**Addendum No. 1**

Subject: McMICHAEL ELEMENTARY SCHOOL  
CLASSROOM MODERNIZATION  
SDP CONTRACT NOS. B-041 C, B- 043 CC

This Addendum, ***dated 9<sup>th</sup> of May 2018***, shall modify and become part of the Contract Documents for the work of this project. Any items not mentioned herein, or affected by, shall be performed strictly in accordance with the original documents.

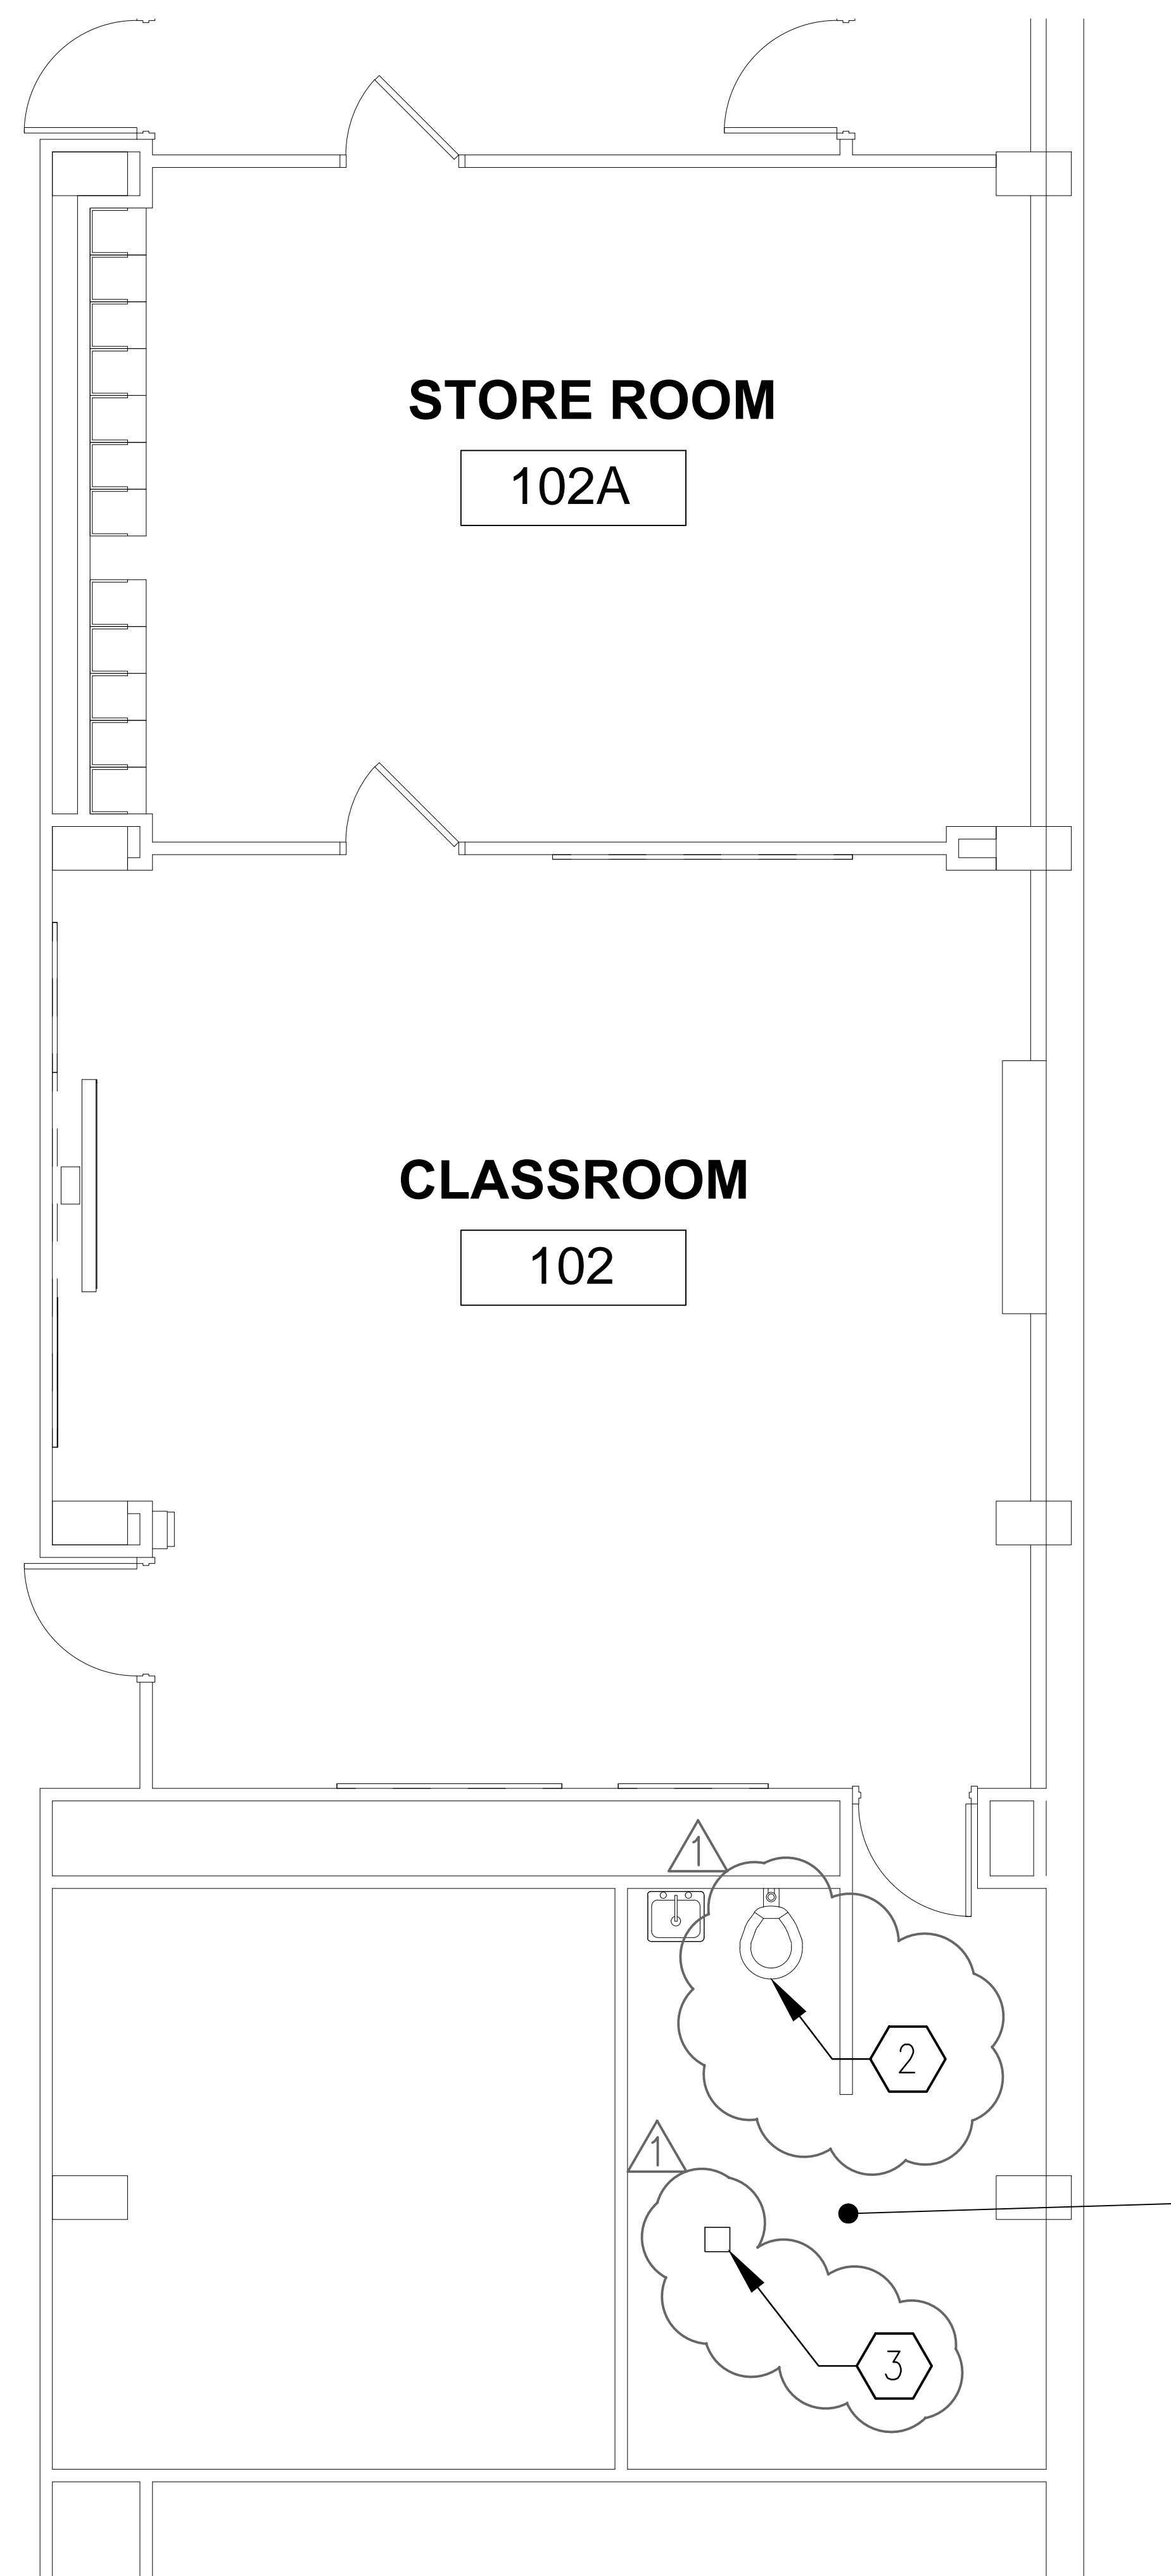
**PLUMBING KEY NOTES**

1 DISCONNECT EXISTING SINK INCLUDING BUT NOT LIMITED TO SANITARY, DOMESTIC COLD & HOT WATER, VENT & REMOVE EXISTING SINK, FAUCET & TRIMS. PROVIDE NEW VALVES AND CAP WATER AND LINES SECURELY PRIOR TO SUBSTANTIAL COMPLETION. PROVIDE NEW SINK AND ACCESSORIES AS SPECIFIED & REQUIRED & RECONNECT TO EXISTING SANITARY, DOMESTIC COLD & HOT WATER PIPING & VENT. EXTEND & REPLACE EXISTING PLUMBING PIPING AS REQUIRED TO MAKE THE NEW FIXTURE FULLY FUNCTIONAL.

2 DISCONNECT EXISTING WATER CLOSET INCLUDING BUT NOT LIMITED TO SANITARY, DOMESTIC COLD WATER, VENT & SECURE FOR RE-INSTALLATION AFTER NECESSARY GC WORK IS COMPLETED. THE CONTRACTOR SHALL COORDINATE WITH GC & RE-INSTALL THE FIXTURE. EXTEND AND/OR PROVIDE NEW PLUMBING PIPING, FLUSH VALVE TO MATCH EXISTING AND ACCESSORIES REQUIRED TO MAKE THE FIXTURE FULLY FUNCTIONAL.

3 FIELD VERIFY EXACT LOCATION & REMOVE & REPLACE EXISTING FLOOR DRAIN AND ASSOCIATED SANITARY TRAP & PIPING TO THE EXTENT REQUIRED TO INSTALL AND CONNECT NEW FLOOR DRAIN. COORDINATE WORK WITH EXISTING CONDITIONS AND GC. NEW FLOOR DRAIN SHALL BE JAY R SMITH 2050; SIZE TO MATCH EXISTING FLOOR DRAIN.

# Metal Box Speakers

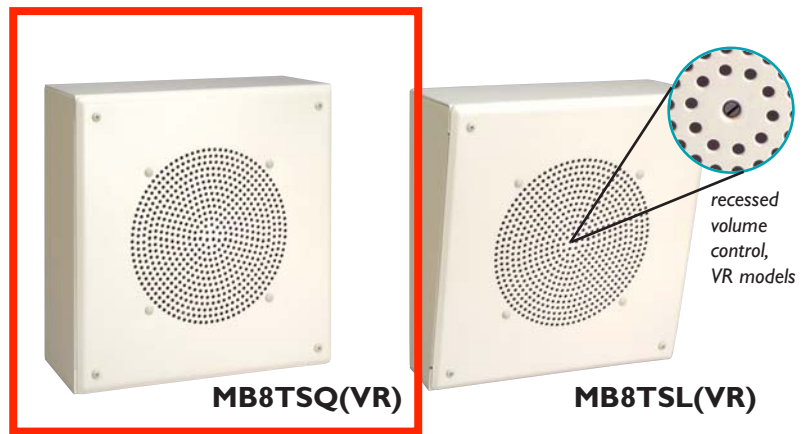
.10 **Clarification:** Where EC is to replace non-functioning speakers and wall telephones the EC shall provide the speakers (see attached cut sheet). SDP will furnish new telephone handsets for installation by EC.
